I.	Projec	t Information		
Project	Name:	Oak Hill Parkway (U.S. Highway (US) 290/State Highway (SH) 71)		
Project	Limits F	From: US 290 W - State Loop 1 (Mopac); SH 71 - US 290 W		
Project	Limits T	o: US 290 W – Ranch-to-Market Road (RM) 1826; SH 71 – Silvermine Drive		
Main C	SJ of pr	eviously cleared project: <b>0113-08-060, 0700-03-077</b>		
Associa	ate CSJ(	(s) of previously cleared project: <b>N/A</b>		
		being done for work that will be done under a new CSJ that will need to be added to the red main CSJ?		
		Yes		
	$\boxtimes$	No		
If so, in	dicate th	ne new CSJ(s): <b>N/A</b>		
District	Austin			
County	(ies): <b>Tr</b>	avis		
Origina	l Approv	ved Environmental Classification (if "CE," also include the type and criterion): <b>EIS</b>		
Origina	l Enviro	nmental Clearance Date: Dec 21, 2018		
laws fo	The environmental review, consultation, and other actions required by applicable Federal environmental laws for this project are being, or have been, carried-out by TxDOT pursuant to 23 U.S.C. 327 and a Memorandum of Understanding dated December 9, 2019, and executed by FHWA and TxDOT.

II.	Reeval	luation Number		
Reeval	uation n	umber: 3		
III.	Reaso	n for Reevaluation		
If there

Revise WB US 290 to WB SH 71 access to a signalized dual right turn

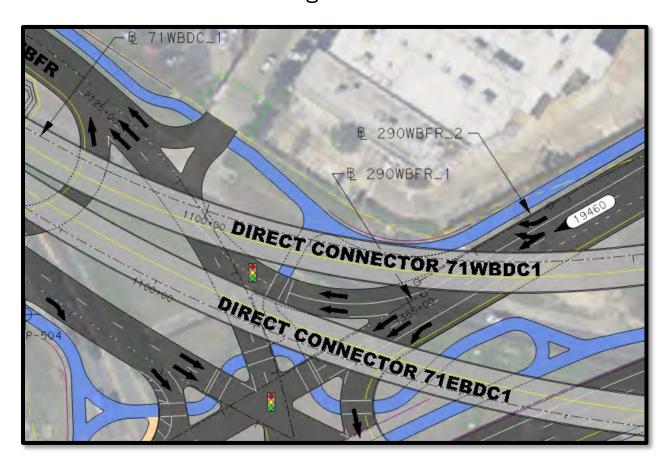
- 1) Revise westbound US 290 to westbound SH 71 access to a signalized dual right turn. This change modifies the frontage road intersection configuration—specifically, the westbound US 290 to westbound SH 71 movement. The change removes the sweeping right-turn movement and adds two right-turn lanes with a new signal to control the proposed movement. The purpose is to alleviate expected weave issues on westbound SH 71 between the US 290 westbound frontage road and the HEB Turnaround.
- 2) Add a 200-foot-long right-turn deceleration lane on the US 290 eastbound frontage road at Scenic Brook Drive.

Add a 200-foot-long right-turn deceleration lane on the US 290 eastbound frontage road at Scenic Brook Drive

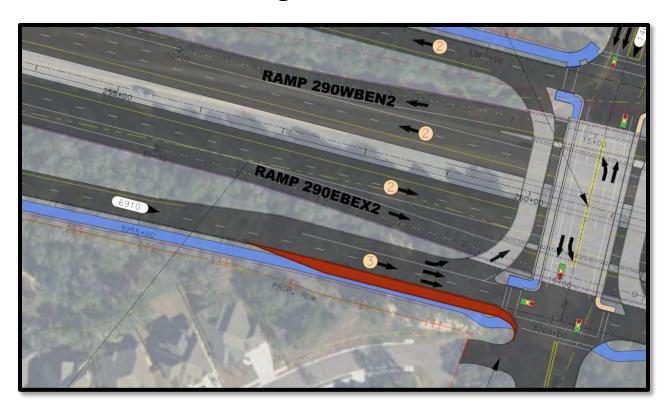
This change adds a 200-foot-long right-turn deceleration lane along the eastbound frontage road at the approach to Scenic Brook Drive. The proposed shared-use path location is shifted to accommodate this addition.

Add emergency access to Scenic Brook Drive

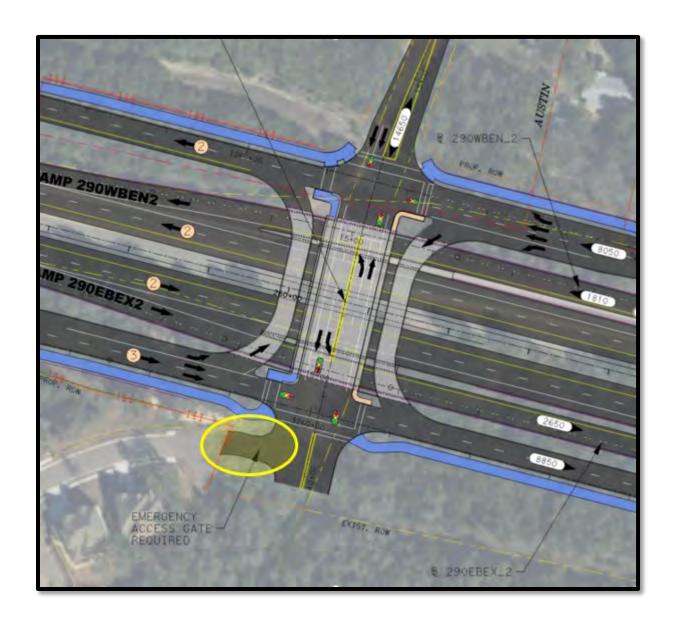
3) Add emergency access to Scenic Brook Drive.

This change entails adding an access point to reestablish the existing emergency access from Lookout Cliff Pass to Scenic Brook Drive. The proposed connection is not included in the RFP Schematic Design.

Shift the Parcel 22 driveway west and add channelization

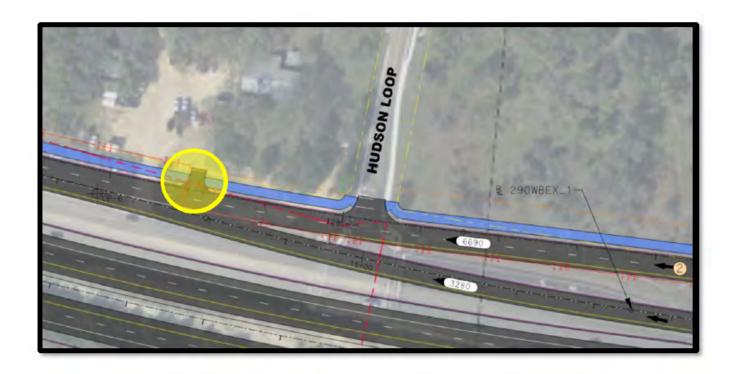
4) Shift the Parcel 22 driveway west and add channelization.

This change relocates the driveway for Parcel 22 to the west by approximately 100 feet to coincide with the control of access shown in the right-of-way (ROW) maps. This revised driveway location is within the striped gore of the Scenic Brook Drive exit ramp, requiring ramp channelization methods from the end of the physical gore to past the driveway.

Eliminate the westbound entrance ramp east of Scenic Brook Drive by adding a collector-distributor road

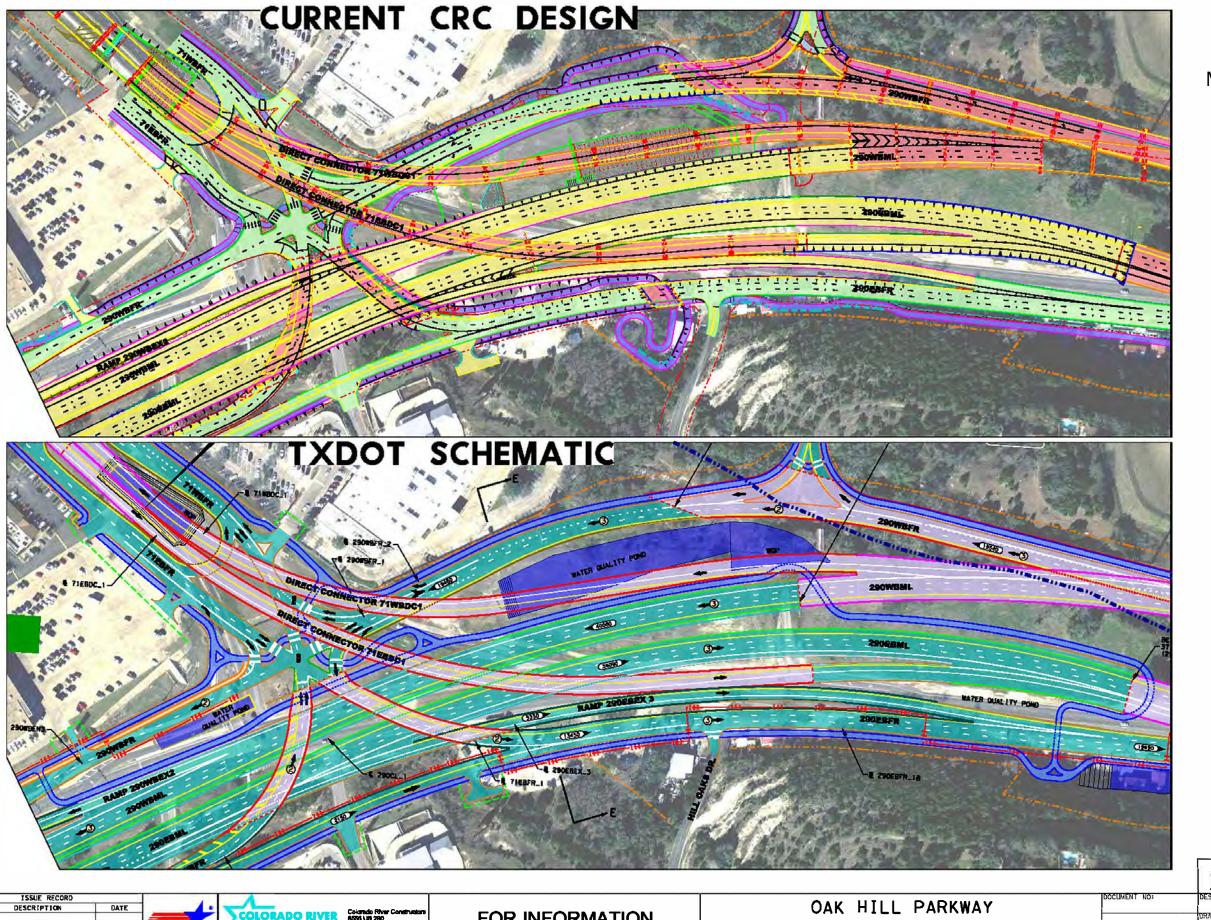
This proposed change will remove the proposed entrance ramp and replace it with a single-lane collector-distributor road to bypass the Scenic Brook Drive signalized intersection. Instead of entering to the mainlanes and adding the third mainlane, it will re-enter the frontage road west of Scenic Brook Drive as an auxiliary lane, which will extend to the entrance ramp to just east of Circle Drive. The third mainlane then would be added with the westbound entrance ramp near Circle Drive.

Changes to Noise Barrier (NB) 4 / Soundwall (SW) 1105 located along the eastbound US 290 roadway between Old Fredericksburg Road and Westcreek Drive

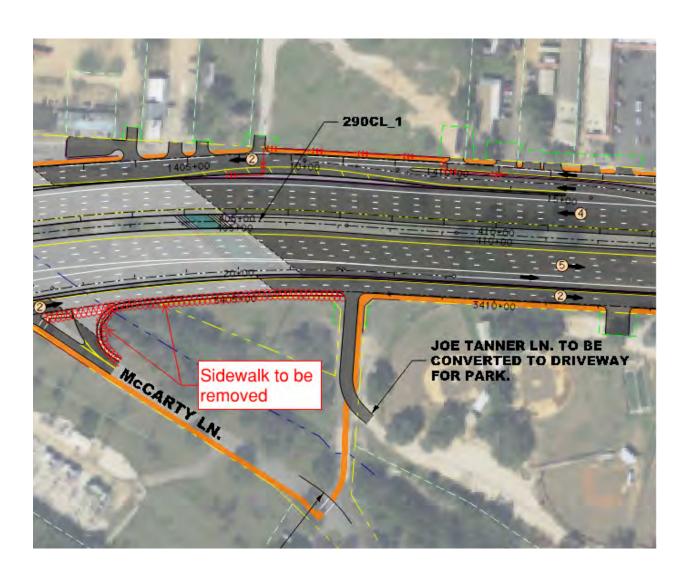
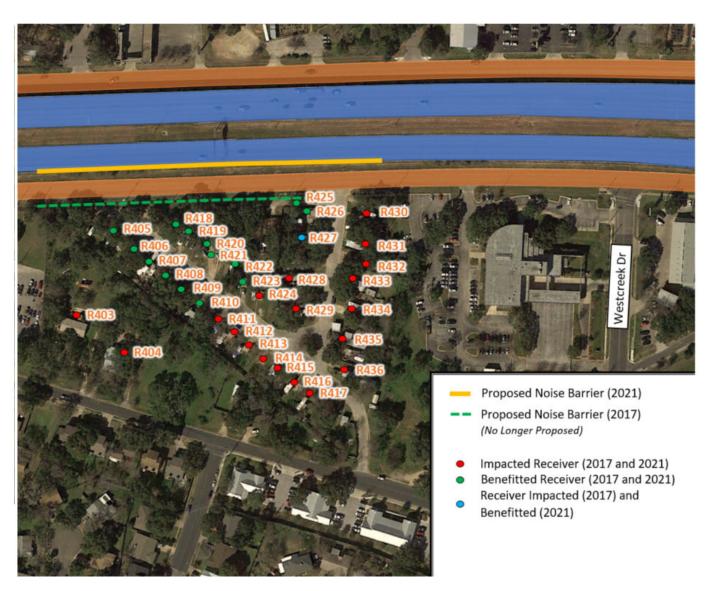
10) Changes to Noise Barrier (NB) 4 / Soundwall (SW) 1105 located along the eastbound US 290 roadway between Old Fredericksburg Road and Westcreek Drive.

Relocation of NB 4 from the ROW to a location between the US 290 eastbound mainlanes and eastbound frontage road. After relocation, NB 4 would be located on the outside edge of the eastbound mainlanes along retaining wall (RW) 170. NB 4 was moved due to utility conflicts along the ROW. Refer to the exhibit within the attached noise memo (Attachment F).

## Oak Hill Parkway Noise Barrier 4 Design Change

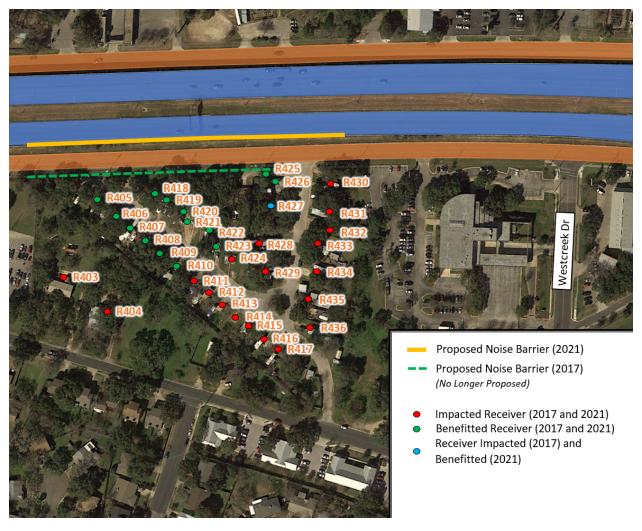
However, during final design of the noise barrier in question (Noise Barrier #4), it was found that the location of the barrier conflicted with multiple subsurface utilities in addition to above ground utilities. Conflicts include;
